OGLE PETROLEUM INC.

RE: Bison Basin Project  
Docket No. 40-8745  
Source Material Lic. SWA-396

SUBJECT: Minor Environmental Amendment Request  
pertaining to Leak Detection System  
for Evaporation Ponds

**LEAK DETECTION SYSTEM  
DESIGN**

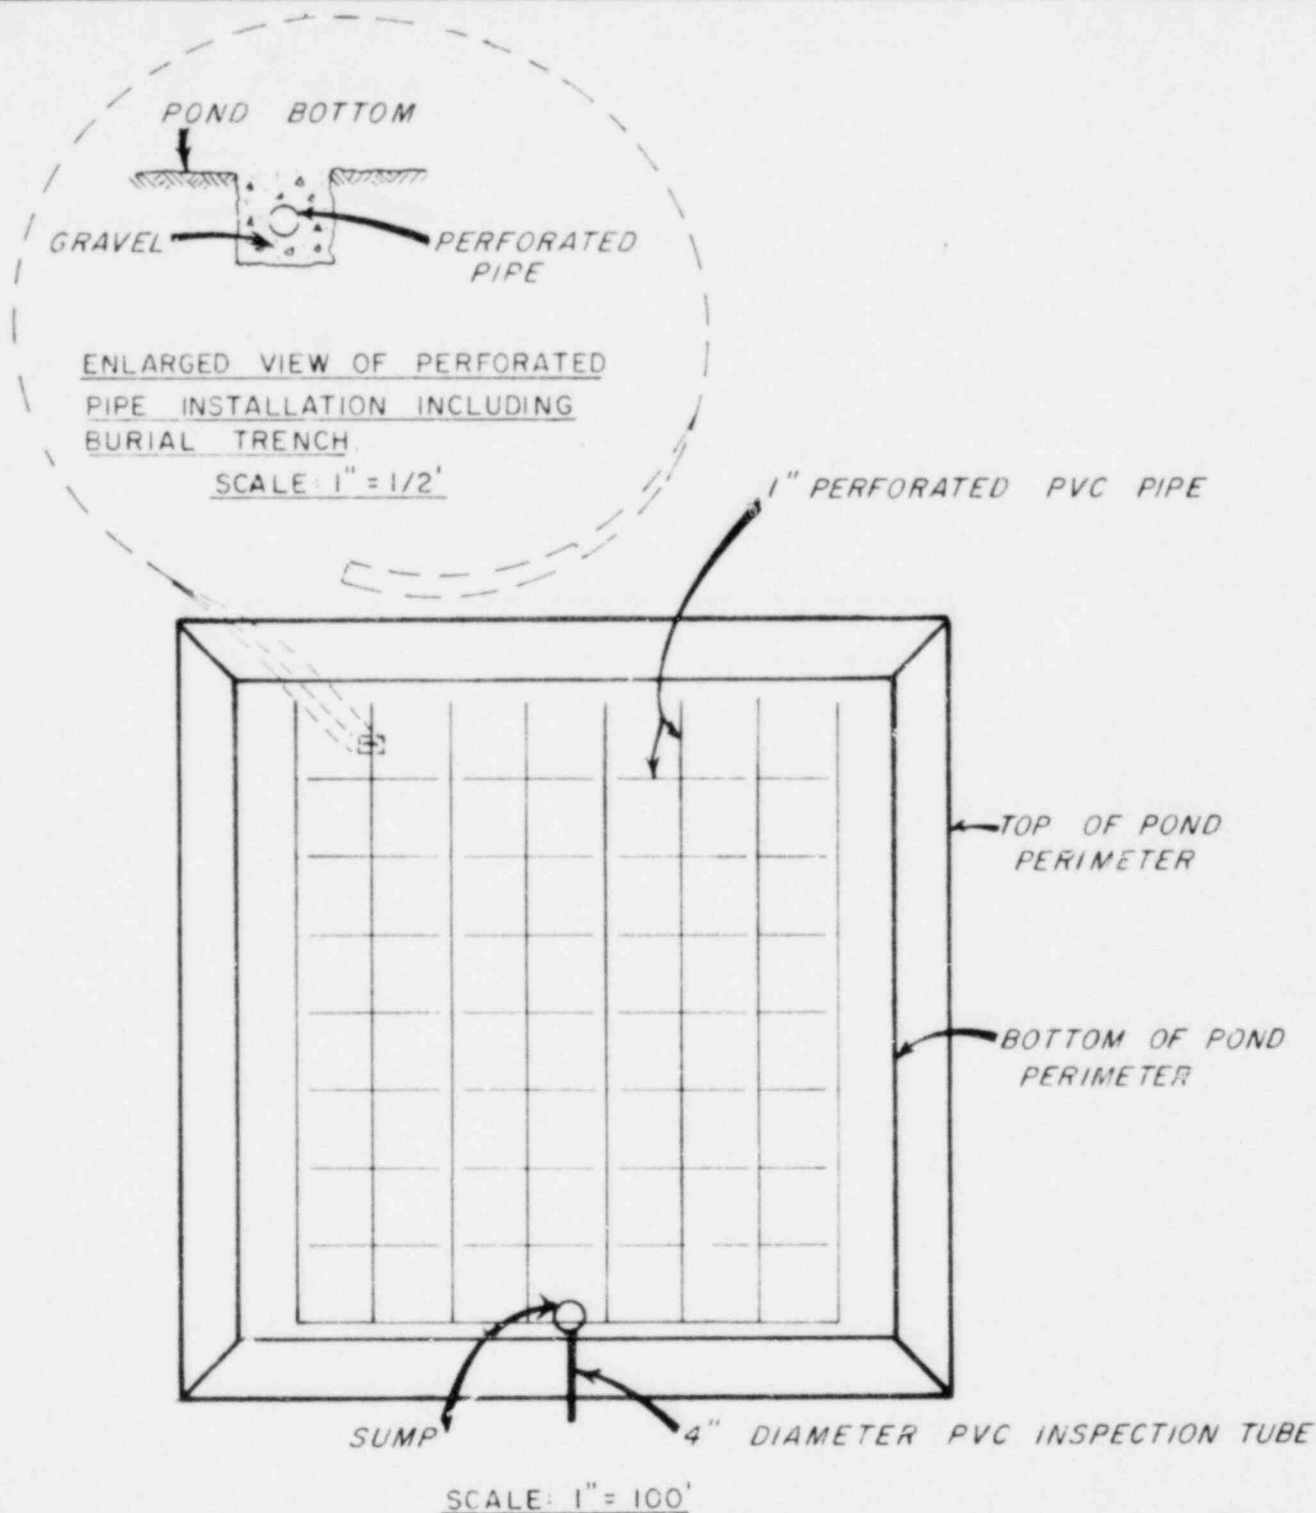
This cost represents about 1/3 (33%) of the total cost of the first pond including stripping, excavation, embankment constructing, hypalon liner, and liner installation. In view of this relative high cost OPI seeks a modification to Amendment 1 (and to item 9 of OPI's QA program) that will allow for a more cost effective leak detection system but still provide the desired environmental protection.

In order to achieve the above stated objectives, OPI proposes the following modification to the leak detection system. A check in the amount of \$760 to cover the minor environmental request fee is enclosed. First, the 3 rows of 4" perforated PVC piping spread approximately 120 feet apart would be replaced by 1" perforated pipe in a grid pattern using 40 feet spacing (see enclosed drawing). Under the old arrangement, leaking pond water could have to travel 60 feet (or even as much as 240 feet for a small leak that travelled down gradient and did not spread out). Under the new proposal, leaking water would only have to travel a maximum of 20 feet before reaching a perforated collection pipe. Second, the 1" perforated pipe would be placed in a small, shallow approximately 3" by 3" trench and surrounded by properly sized gravel that would keep the perforations in the pipe from becoming clogged with fine sands and silt (see enclosed drawing). The shallow trench would act as a mini-sump collecting leaking water from the pond and insuring that it enters the perforated pipe. The hypalon liner would then be placed over the pond bottom. Visual inspection of the soil in the bottom of OPI's first commercial pond on August 4, 1981 (Mr. Dan Gillen of your staff was present) indicated that there was sufficient clay in the soil to provide the relative low permeability needed for the leak detection system proposed above to work.

The above values of permeability are of such a low relative value (clayrange) that it is reasonable to assume that the modification to the leak detection system proposed in this letter would function satisfactorily. OPI would of course still perform (and must pass) the test of the leak detection system specified in item 11 of the QA program.
